Access Compliance Report

Public Rights-of-Way

(Curb Ramps)

Intersection ID: 24700	Main Street: HARLEQUIN_DR	Cross Street: WHISTLING_DUCK_CT	Location: SW
ADA ID: B4D9721F9ECC	Ramp Type: Directional1	Initial Pass/Fail: Fail	Overall Compliance: No
		Severity Score: 21.25

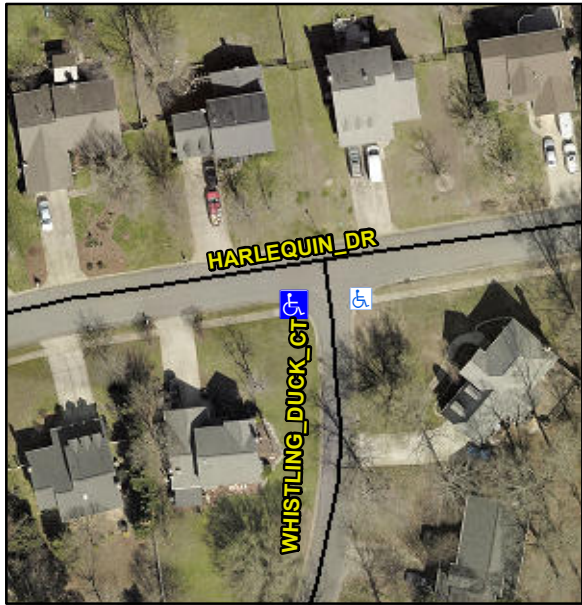
Codes/Mitigation Info/Possible Solution			Field Measurements/Component Compliance					
	Possible Solutions:		Compliance	Description	Data	Compliance	Description	Data
	Remove & Replace Entire Ramp.		N/A	Ramp Length (in)	62.0	N/A	Grade Break?	N/A
			No	Ramp Width (in)	43.0	N/A	Grade Break Slope (%)	0.0
			Yes	Ramp Slope (%)	5.0	N/A	Grade Break XSlope (%)	0.0
			No	Ramp XSlope (%)	5.8			
			N/A	Flare Type LT	N/A	N/A	Flare Type RT	N/A
			N/A	Flare Slope LT (%)	N/A	N/A	Flare Slope RT (%)	0.0
			N/A	Flare Traversable LT?	N/A	N/A	Flare Traversable RT?	N/A
			N/A	Landing Length (in)	0.0	N/A	DWS Provided?	N/A
			N/A	Landing Width (in)	0.0	N/A	DWS Contrast?	N/A
Surveyor Notes:		N/A	N/A	Landing Slope (%)	0.0	N/A	DWS Length (in)	N/A
		N/A	N/A	Landing X Slope (%)	0.0	N/A	DWS Full Width?	N/A
PROW/ADA:		R304.5.1, R304.5.3	N/A	Landing Curb? (Y/N)	N/A	N/A	DWS Offset LT (in)	N/A
			N/A	Shared Landing?	N/A	N/A	DWS Offset RT (in)	N/A

N/A	Gutter Ponding?	0.0	N/A	Gutter Slope (%)	N/A
			N/A	Gutter Lip Ht (in)	0.0	N/A	Gutter X Slope (%)	N/A
			N/A	Painted X Walk1?	No		Road Slope (%)	1.0
				X Walk 1 Direction	To NE		Road X Slope (%)	2.8
				X Walk 1 Width (in)	N/A		Clear Space?	N/A
				X Walk 1 Slope (%)	1.0	N/A	Clear Space to XWalk (in)	N/A
				X Walk 1 X Slope (%)	2.8	N/A	Storm Grate/Utility Hazard?	N/A
			N/A	Ramp inside XWalk1?	N/A		Storm Grate/Utility Type	
			N/A	Any Obstructions?	N/A			N/A
				Obstruction Type		Yes	Surface Condition? (G/P)	Good
						N/A	Curb Slope (%)	16.8
Total Cost:		\$ 1600.00
